REQUEST FOR PROPOSALS ADDENDUM REYNOLDS SCHOOL DISTRICT DESIGN-BUILD

Original RFP issued September 25, 2023
Addendum 1 issued October 10, 2023

This Addendum 01 forms a part of the Contract Documents and modifies the original Bidding Documents as noted below. This Addendum consists of a title page, 3 pages of clarifications and answers to questions, 2 pages of Exhibit A showing the Pre-proposal meeting attendees and 8 pages Exhibit B identifying additional performance specifications of the Reynolds elementary school play areas included in this program.

Hartley Elementary School

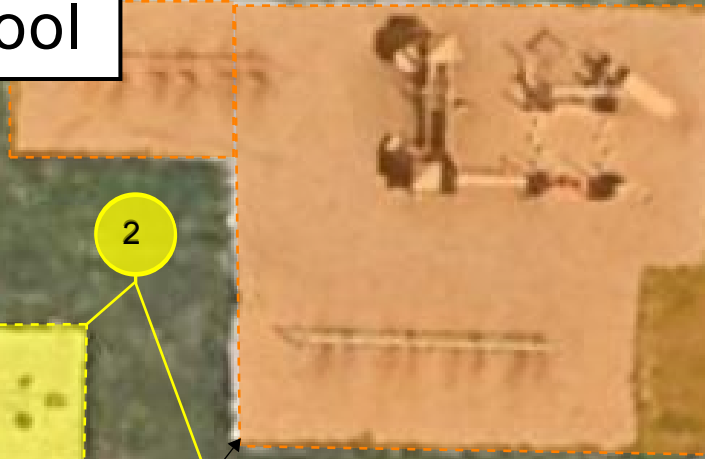
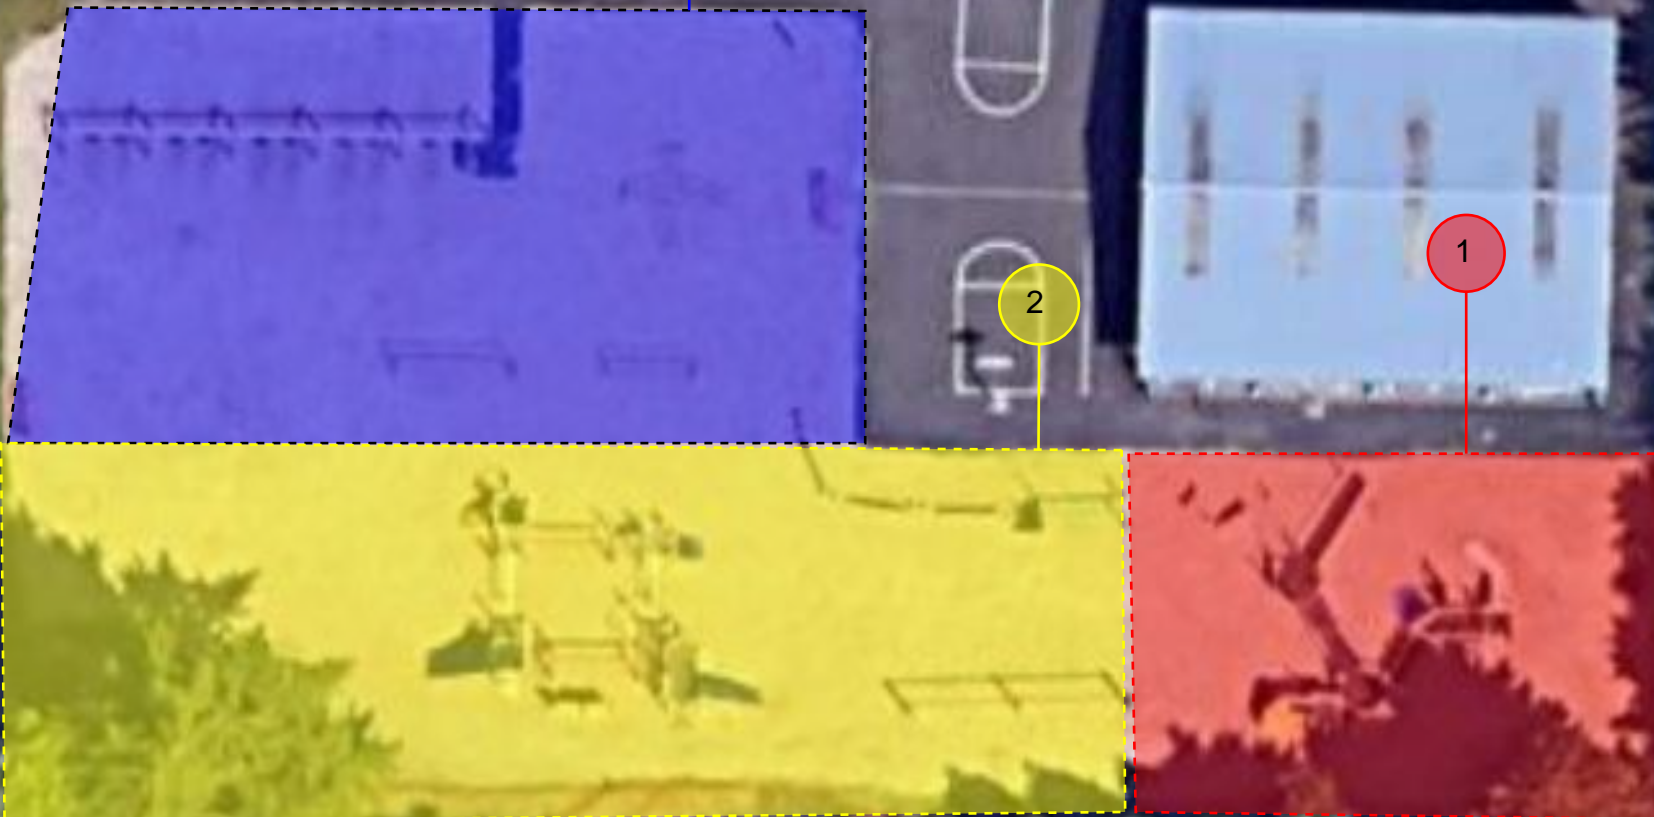
Existing to remain, no work in this area

Demolish play equipment, remove engineered wood fiber, seed areas with grass

Remove old play equipment if budget allows

Provide ADA connection to Area 5

Resurface large main play area
